केन्द्रीय चिड़ियाघर प्राधिकरण
Central Zoo Authority

F. No. 19-23/93-CZA(256)(Vol.III)(M)

Sub:- Designs submitted for the proposed construction of Clouded leopard, Pig tailed macaque, Spectacled langur and Binturong as part to ongoing Conservation Breeding Programme at Sepahijala Zoo, Sepahijala, Tripura.

CONST. OF PIGTAL MACQUE ENCLOSURE WITH NIGHT SHELTER ROOM FOR
 CONSERVATION BREEDING PROGRAMME & QUARANTINE ENCLOSURE AT
 SEPAHJALA 200

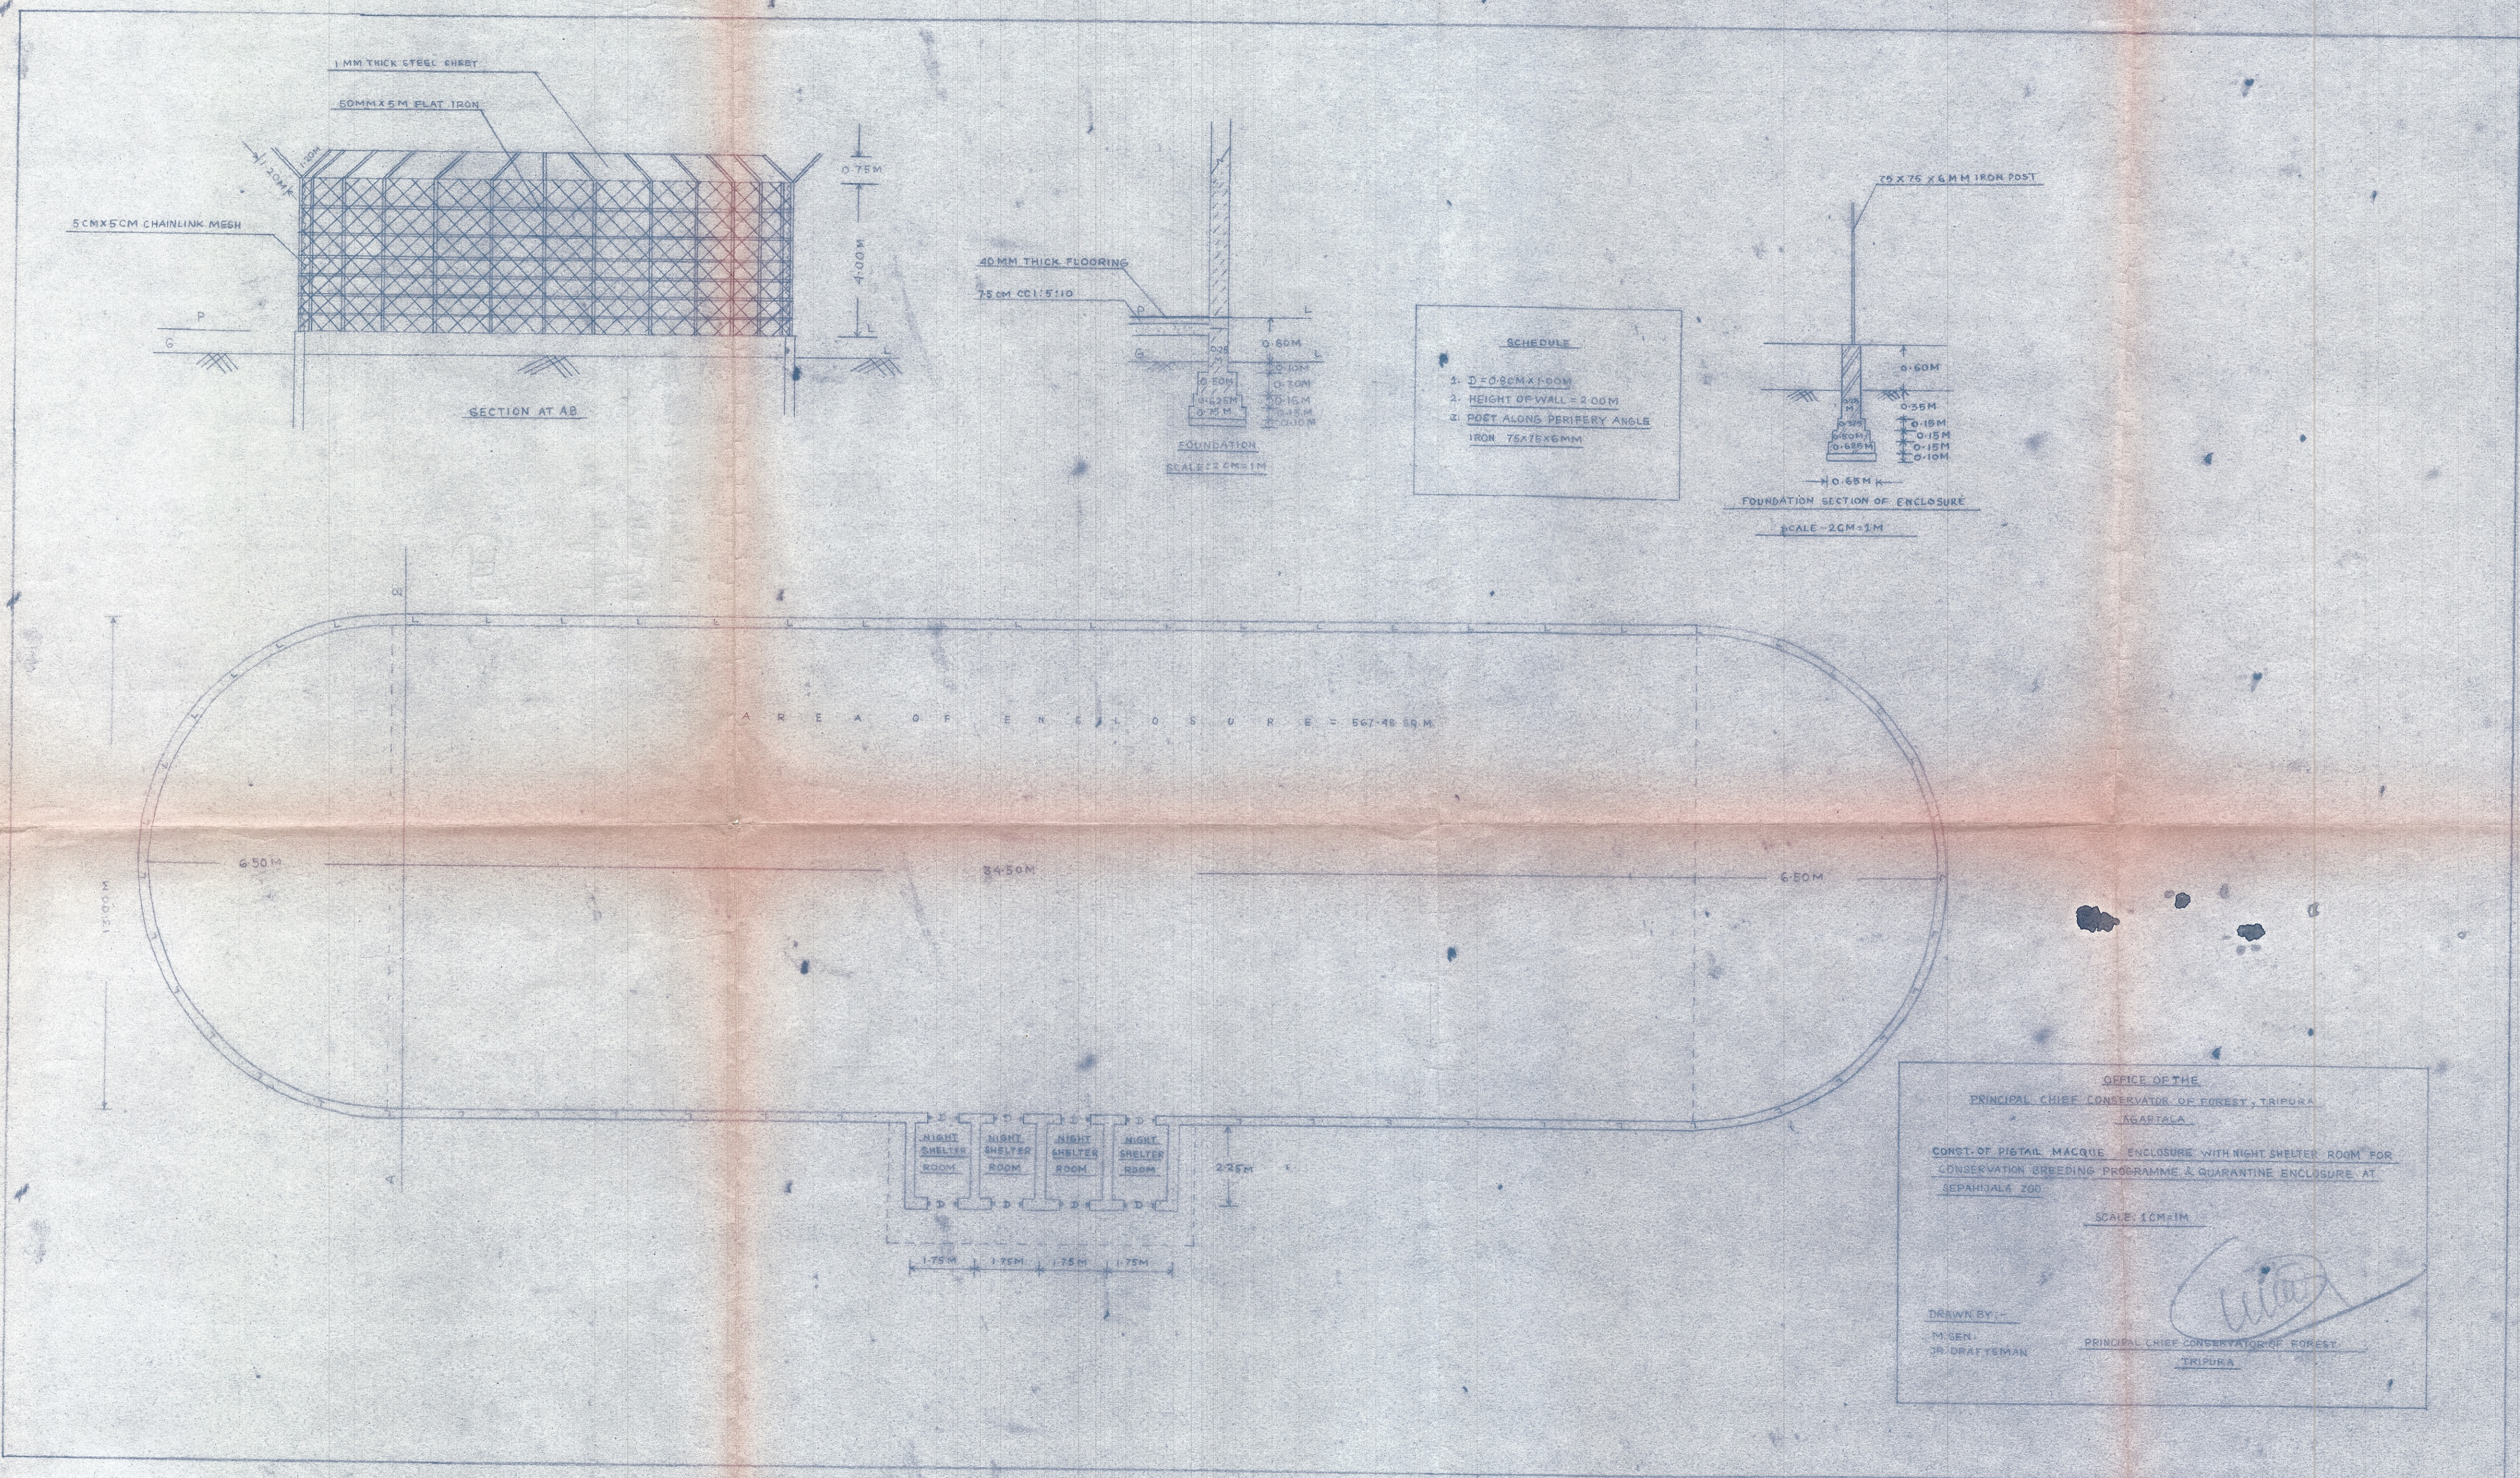
1. Enclosure for Clouded leopard, Pig tailed macaque & Spectacled langur

The Members approved the designs subject to that the following amendments should be made:-

- (i) The minimum width of all the enclosures should be increased to 25-30 meters, keeping in view of the available area.
- (ii) The width of the proposed inward inclined overhang with steel plate should be made of minimum 1.25 meters.
- (iii) The provision of attached/ associated toilet in project office should be made.
